Napa County Office of Education  
Administration Bldg. & Camille Creek  
Battery Energy Storage System

## Addendum 1:

Camille Creek Existing Conduit Map

POI Location Clarification

## Camille Creek Existing Conduit Map

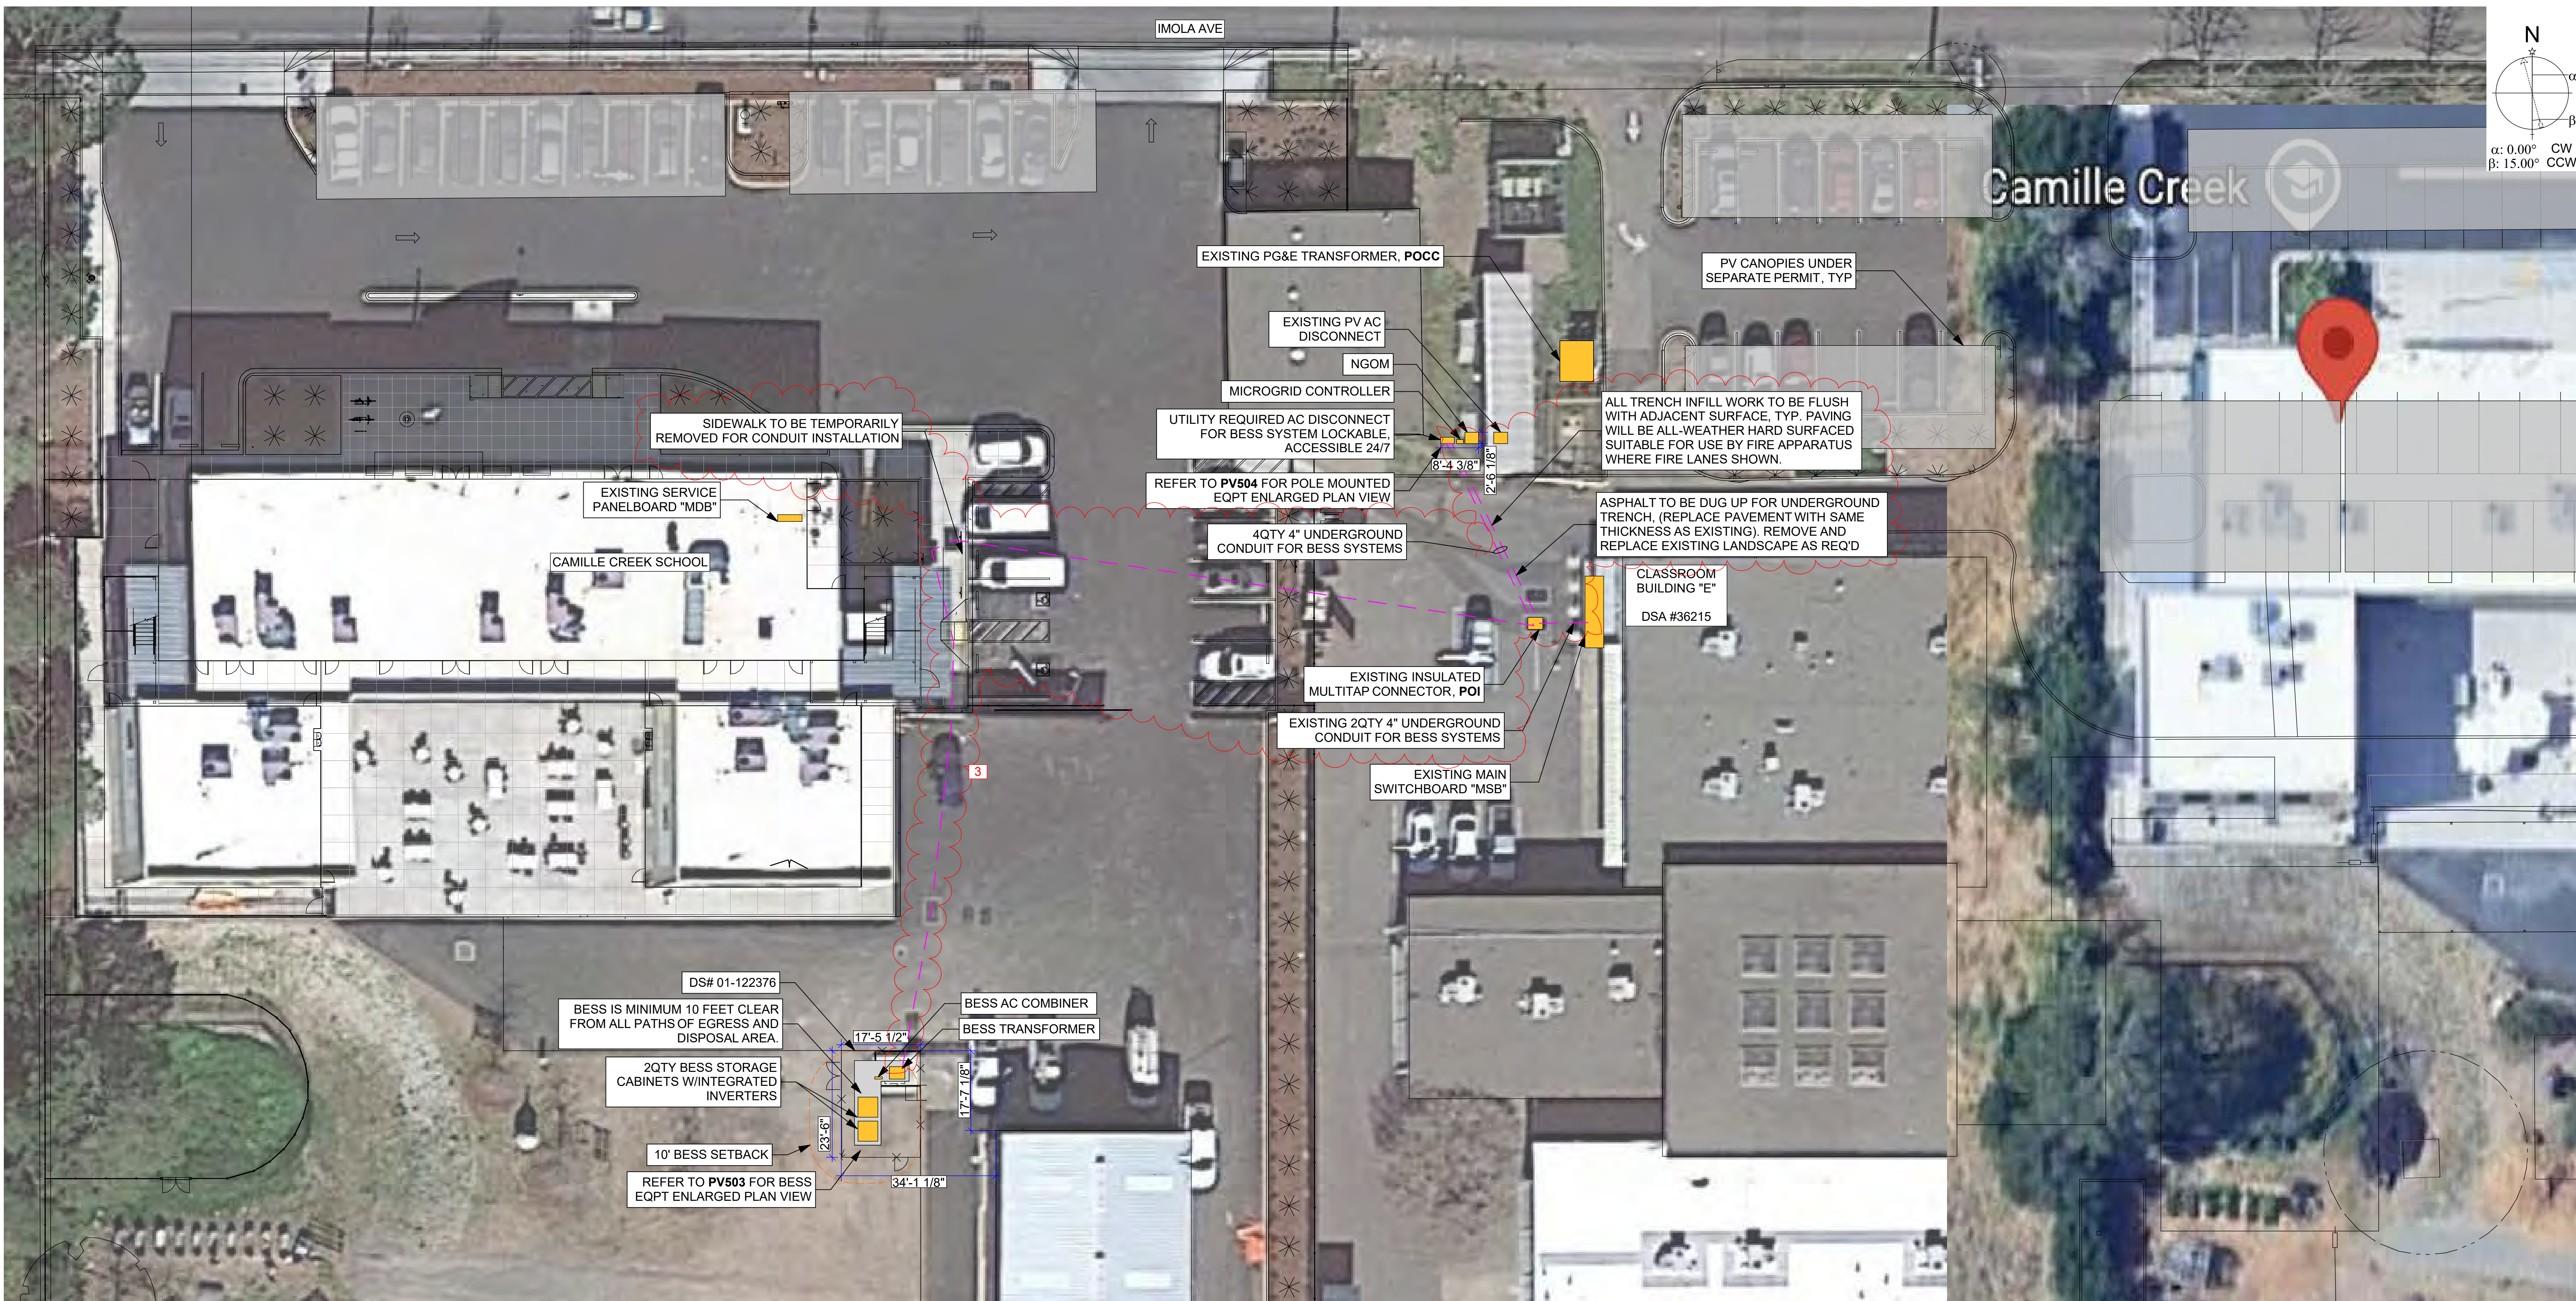
Equipment Pad to A: = no existing conduit, must be excavated and installed

A to B: existing conduits = (3) 4", (2) 2" & (1) 1"

B to C: existing conduits = (3) 4", (2) 2" & (1) 1"

C to D: no existing conduits. A section of sidewalk will have to be removed, conduits installed, and the sidewalk re-poured "See Below"

D to E: existing conduits = (3) 4"

E to AC Disconnect: no existing conduits. Asphalt must be excavated, conduits installed, and asphalt patched

PV001

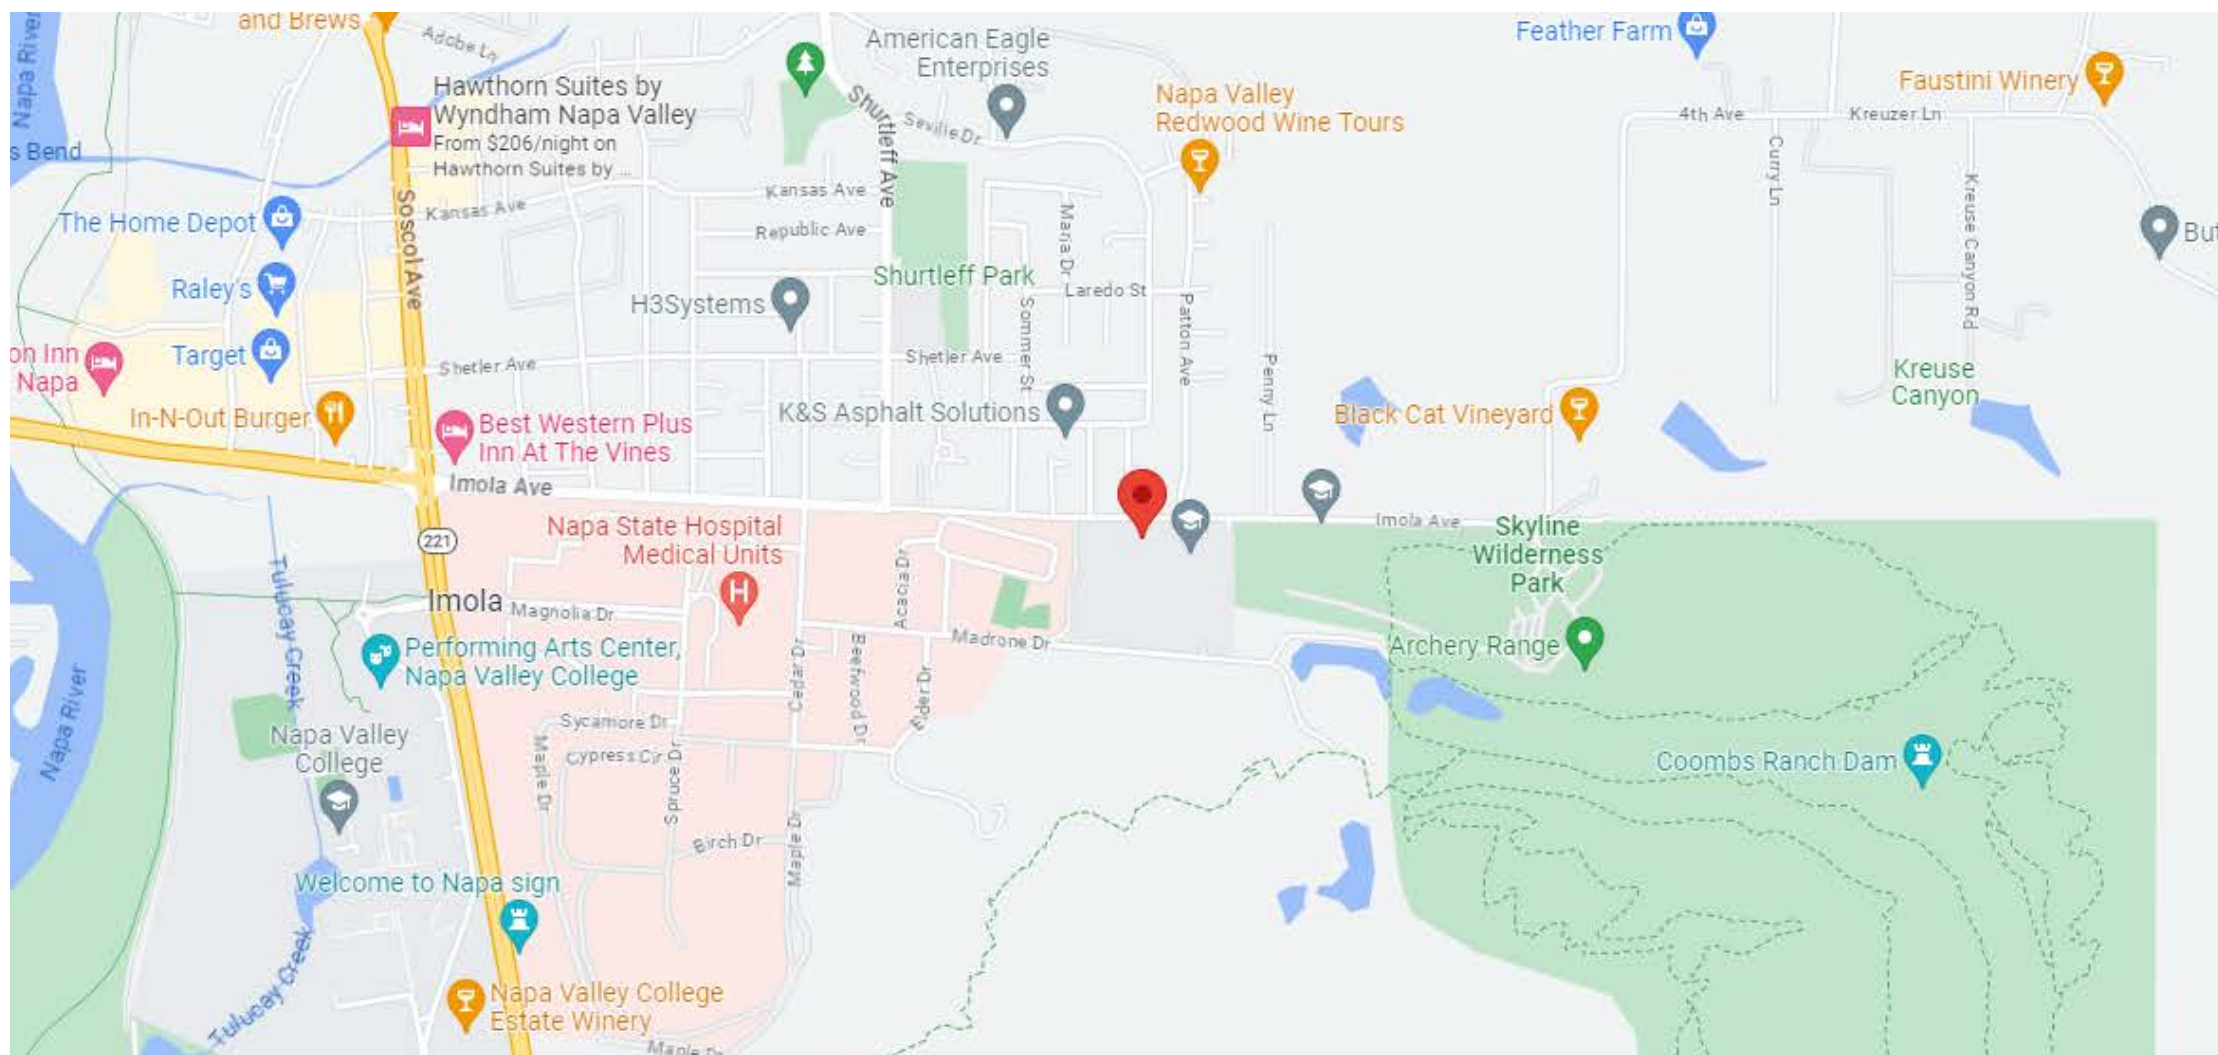
| CLIENT                   |                            |            |
|--------------------------|----------------------------|------------|
| 3                        | ADDENDUM 1                 | 08/24/2026 |
